PLAN COMMISSION STAFF REPORT

Agenda Item: PC Docket No. 21-006

Application: Development Plan Conditions Amendment

Summary: Amit Shah, HP Munster Investment LLC requesting to amend Conditions of a previously approved Development Plan for the Hyatt Place Hotel at 9420 Calumet Ave.

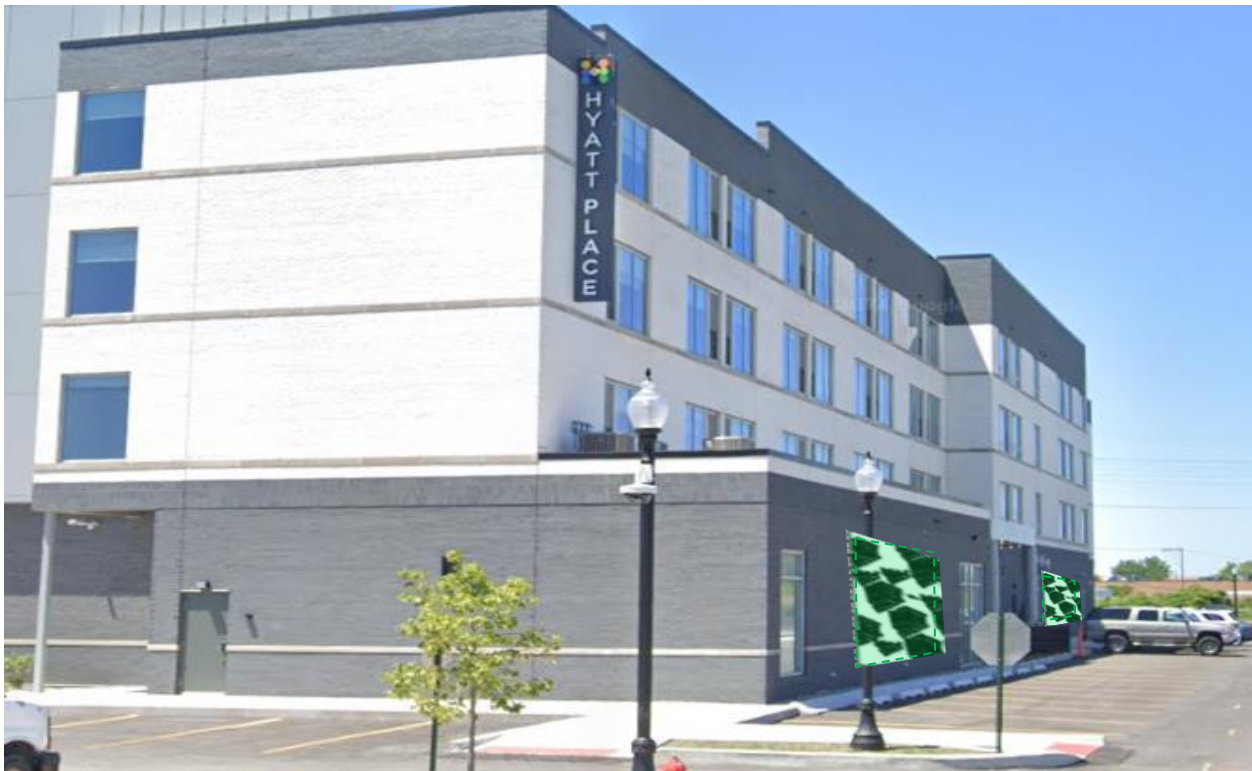
On August 10, 2021. The Plan Commission held a Public Hearing on the Development Plan for Hyatt Place Hotel. At said meeting, members of the commission expressed concerns with aesthetic of the ground floor north wall. Discussion ensued among the commissioners and the petitioners regarding faux windows, landscaping, and including a “living wall.”

At the conclusion of the public hearing meeting a motion was presented and approved to accept the development plan as presented with minor adjustments to the north wall with Town Planner’s approval. The Findings of Fact presented included language that reads “The north wall of the hotel will include a ‘living wall’.”

Mr. Amit Shah represents that the development plan is unchanged from its approval, except for the living wall installation. He has expressed concerns with the retrofit and maintenance of the living wall and finds that the appearance of a living wall will be less desirable and visually appealing during winter weather conditions. Mr. Shah is now requesting consideration from the Plan Commission to amend the Findings of Fact and remove language that reads “The north wall of the hotel will include a ‘living wall’” and forgo the installation of a living wall to satisfy the conditions of approval on the Findings of Fact to obtain a final occupancy.

- Amend the Findings of Fact to remove the living wall condition and find compliance with the Development Standards of the existing building design of the filed development plan.
- Amend the Findings of Fact to take into account consideration of all relevant material factors, conditions, and discussion of the Façade Articulation referenced in Table 26-6.405.A-6 and differentiate the façade into segments with approved material that has a defined center and edges with durable qualifying exterior commercial wall art material to visually create a segmented façade articulation

1 NORTH ELEVATION
 SCALE: 1/8" = 1'-0"

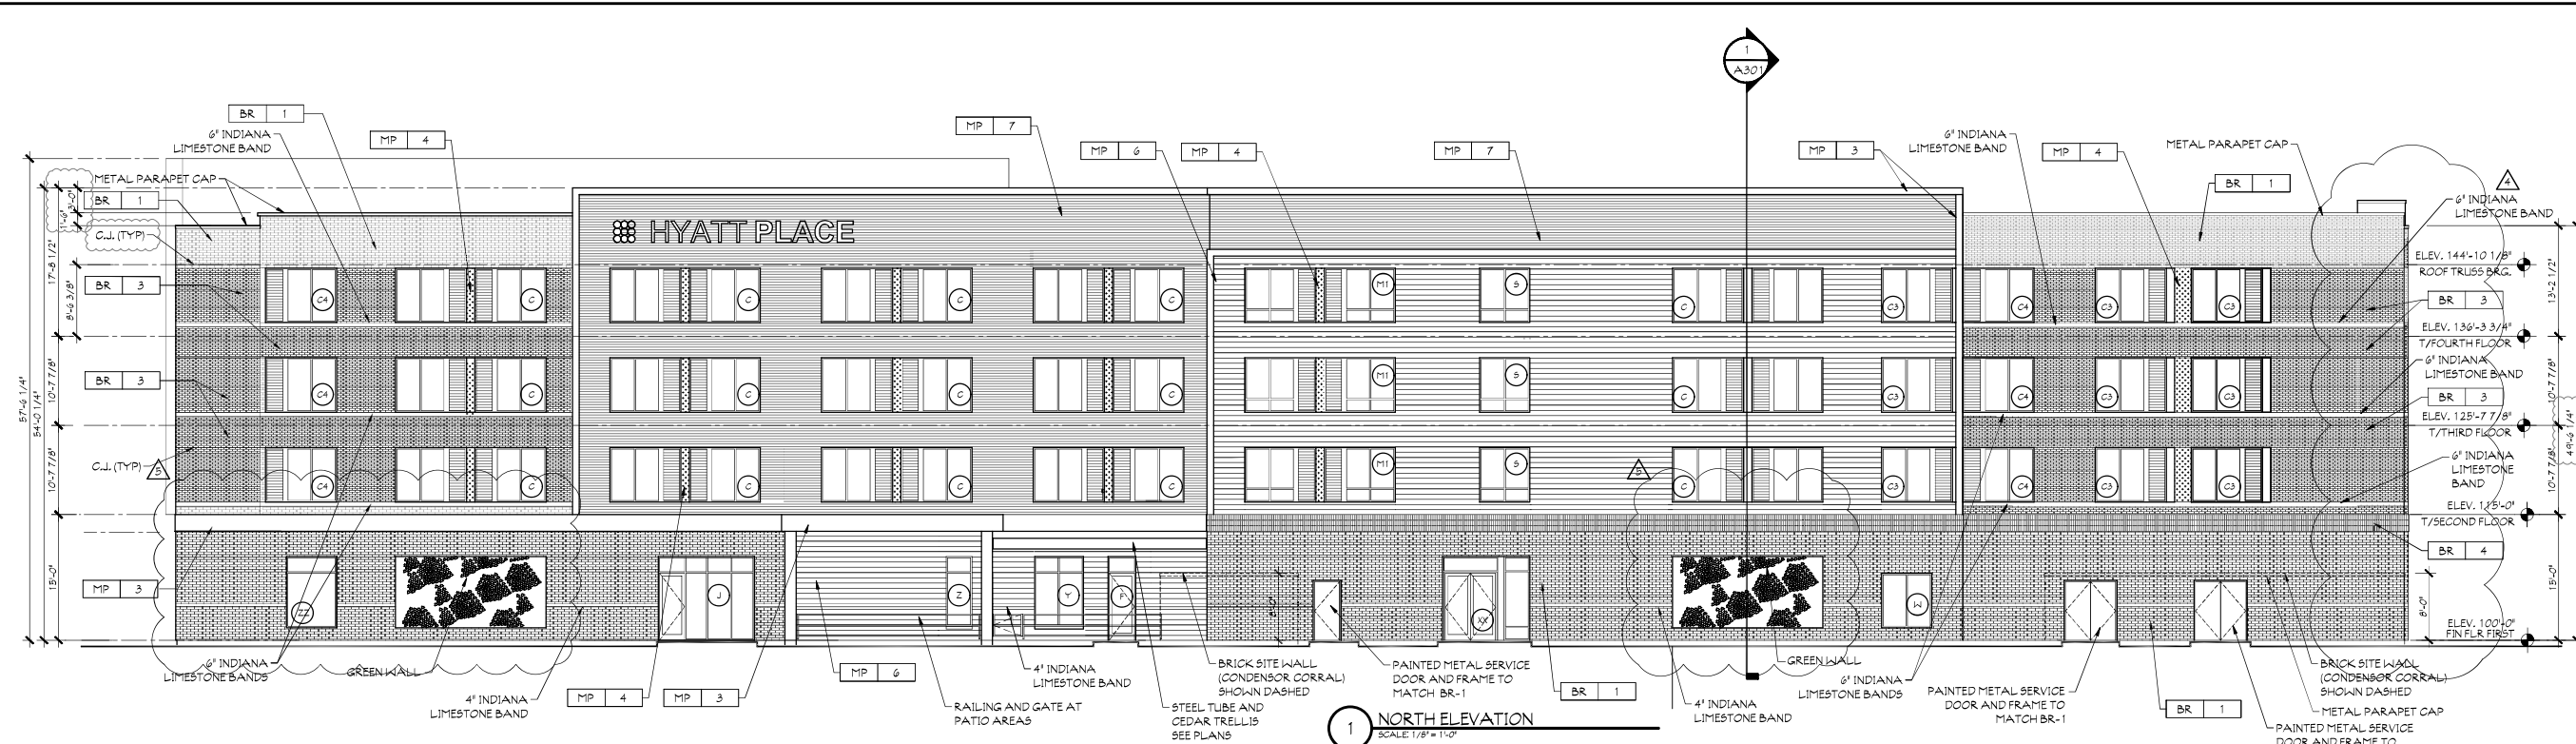
- (a) The north wall of the hotel will include a "living wall".
- (b) Additional windows on the ground floor of the north side should be included to match the existing windows.

Mr. Gardiner suggested that additional windows on the ground floor of the north side to match the existing windows. Mr. Vander Woude said that the site plan does not show any landscaping on the north side of the building.

Mr. Amit Shah asked whether it was just the windows on the north elevation. Mr. Specht replied that it was windows and living wall described by Ms. Mellon.
